Planning reference: 20/01316/TEL56

We have undertaken an assessment into the proposed installation for the proposed 5G Mast (ref. CWL045) on Skimmingdish Lane, Bicester – 459216E / 224155N.

Bicester Motion Aviation Assessment

Aviation Impact Assessment of the Proposed 5G Mast (ref. CWL045) on Skimmingdish Lane, Bicester – 459216E / 224155N

Location of Mast shown with Aviation Infrastructure at Bicester Airfield

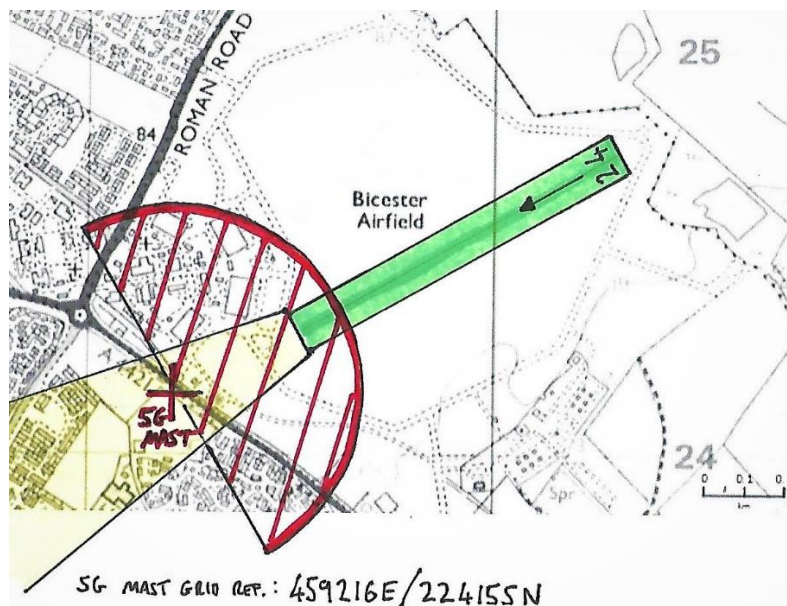
Runway 24 (direction 240°) is shown in green, no area of which, or any runway, should be inside the red hatched area originating from the proposed 5G mast site. The required obstacle free take-off climb surface (1:25 gradient) is shown in yellow.

Chapter 4 of CAP 168 details the assessment and treatment of obstacles and considers the take-off climb surface, which is an inclined plane beyond the end of the take-off run available, that must remain obstacle free. Para 4.8 sets the applicable requirement for an obstacle free climb out based on a 1:25 (4%) aircraft climb gradient. Given an obstacle of 16m in height, this equates to 400m horizontally in addition to the application of the mandatory 60m runway end safety requirement, thus, the distance of the mast from a runway must be 460m.

The result would be shortening the existing Runway 24 (direction 240°) by at least 150m, and a reduction in potential useable flying area within the South Western corner of the flying area, inside the airfield perimeter track, of around 200m. This would have a detrimental impact on existing and future aviation operations at Bicester airfield.
